Detailed Assessment Report

APPLICATION DETAILS	
Applicant:	Mr KM Carroll, Ms H Meyer
Proposal:	Development Permit for Material Change of Use of Premises (Integrated Tourist Facility)
Properly Made Date:	26 November 2015
Information Request Date:	22 January 2016 4 January 2017 – Outstanding Issues sent
Info Response Received Date:	19 October 2016 26 April 2017 – Response to Outstanding Issues
Decision Due Date:	1 June 2017 – 1 st 20 days 30 June 2017 – 2 nd 20 days
Number of Submissions During Public Notification:	TOTAL of 363 submissions <ul style="list-style-type: none"> • 337 properly made • 292 support and 43 against and 2 neutral • 26 not properly made • 329 were proforma
PROPERTY DETAILS	
Division:	7
Property Address:	24 & 26 Box Street BUDERIM
RP Description:	Lot 7 RP 176066 Lot 5 RP 27823
Land Area:	Lot 7 – 28,151m ² Lot 5 – 12,570m ² Total – 40,721m ²
Existing Use of Land:	Single detached house
STATUTORY DETAILS	
Planning Scheme:	Maroochy Plan 2000 (16 September 2013)

The application seeks approval for an Integrated Tourist Facility and associated facilities including a 111 room short term accommodation, function facility, restaurants and day spa.

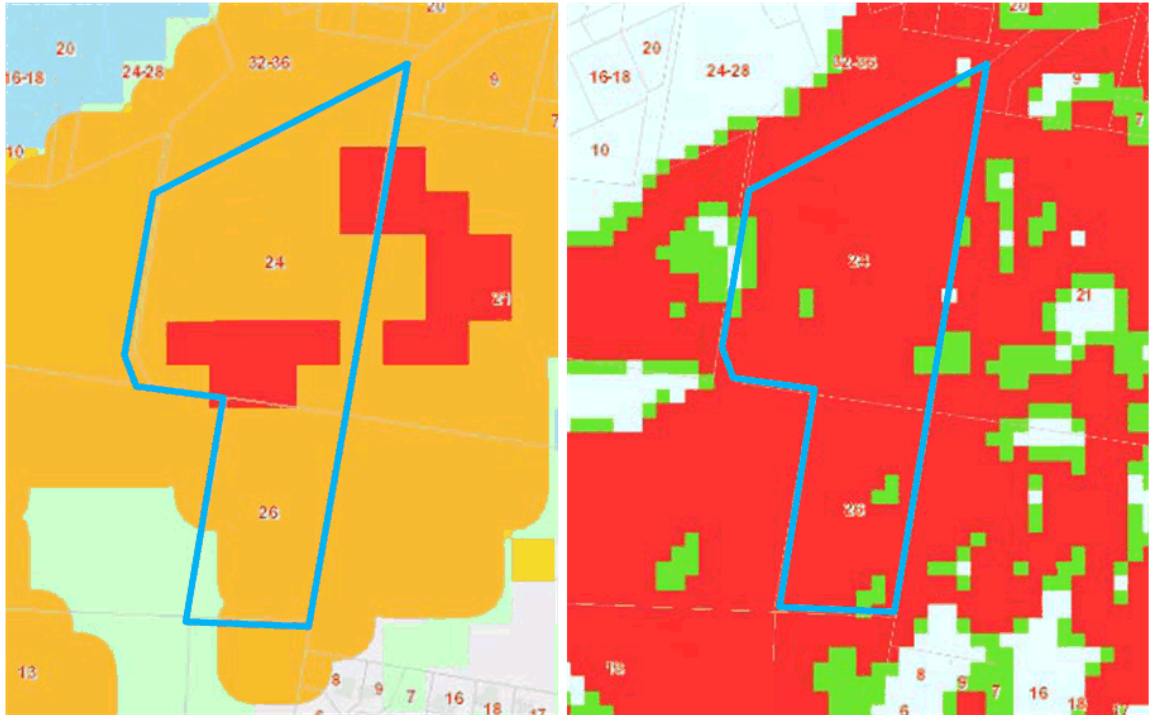
The Buderim Local Area Code identifies that two storeys and 8.5 metres is an acceptable measure or outcome for the urban precincts of Buderim (centre and residential precincts). As a result, the existing built character and prevailing height of those parts of Buderim is approximately 8.5 metres with the exception of some houses on the steeper slopes, which the planning scheme allows to extend to 10 metres high.

While a 10m height allowance for a house provides a guide for the height of dwellings on sloping land, it does not follow that a 10m height allowance may be applied in a broad, sweeping way across the subject site for large-scale commercial buildings that are incomparable to a house and exceeds a house scale excessively. For example, the proposed 'birdwing building' alone is approximately 170 metres long and has a floor area of 3,815m².

The application proposes to deal with this issue through recent design amendments to reduce the height of some parts of the development where closest to the edges of the site, and also to reduce the scale and footprint of the development to enable an uncompromised 10m vegetated buffer on all sides. These matters can be enforced through conditions of approval and are considered to sufficiently address the potential impacts caused by building height.

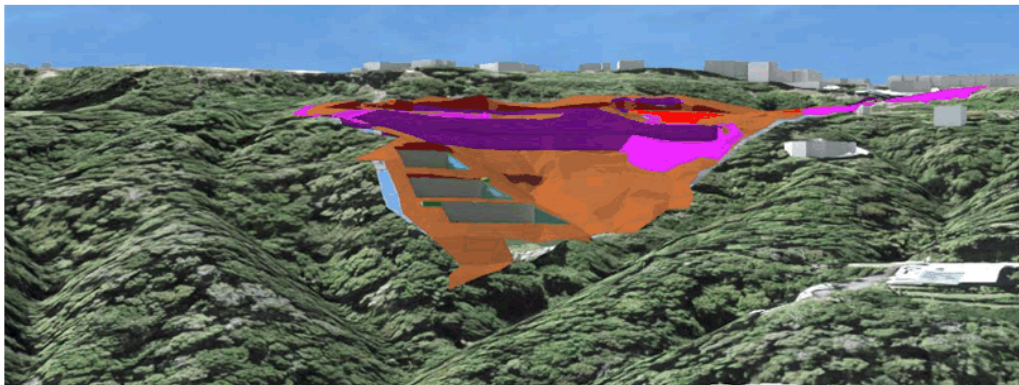
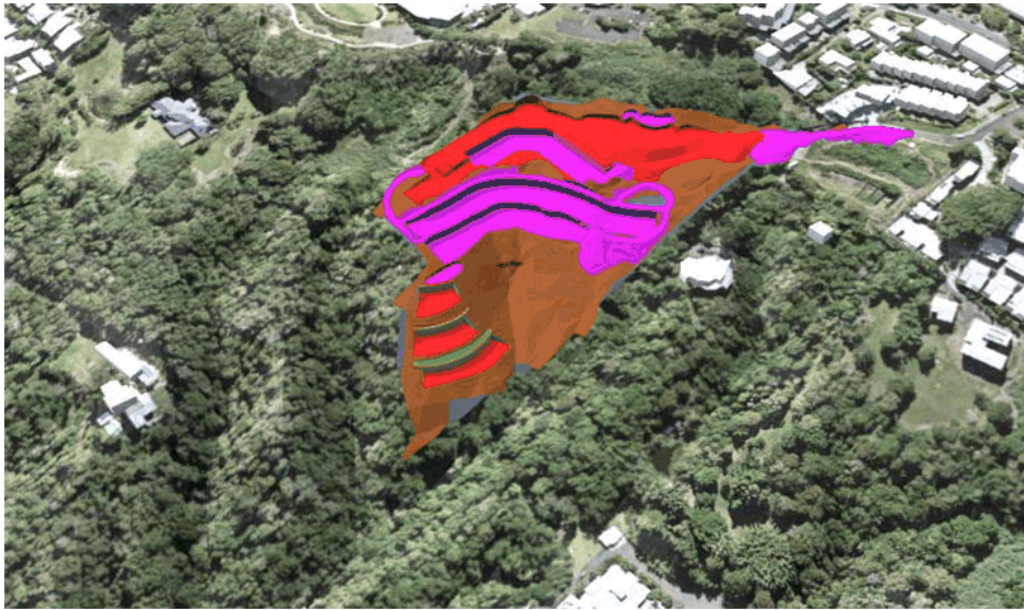
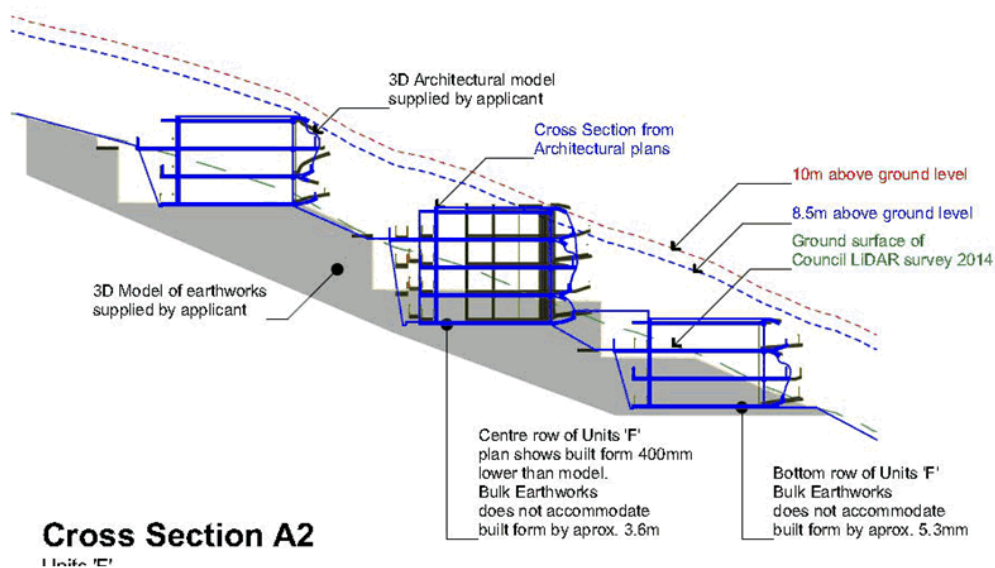
The information provided by the applicant does not align and a detailed assessment has identified a substantial inconsistency between the earthworks model and the architectural plans and model provided by the applicant. The below image overlays the applicant's earthworks model with the applicant's architectural model and reveals a number of issues.

The image shows that the earthworks model has not accounted for the size of the unit buildings being proposed and subsequently the extent of excavation proposed by the applicant has been underestimated. The image identifies that the second and third row of buildings include a storey below the ground. The cut platform in the architectural plans for the bottom row of units is situated about 5.3m below the cut pad in the bulk earthworks plan.

The cut platform in the architectural plans for the middle row of units 'F' is situated about 3.6m below that shown in bulk earthworks plan and the cut platform for the top row of units is situated about 0.4m below the cut pad in the in the bulk earthworks plan.

This discrepancy between the earthworks and architectural models has implications that need to be resolved by conditions of any approval to ensure accuracy of the final building and earthworks outcome. As currently designed, additional cut depths (up to 5.3 metres extra) are required to accommodate the proposed units. Alternatively, the buildings would need to sit higher out of the ground, bringing them well over 10 metres high. Conditions of approval are recommended to resolve all inconsistency between the final designed earthworks and architectural models through a more detailed and thorough package of amended plans.
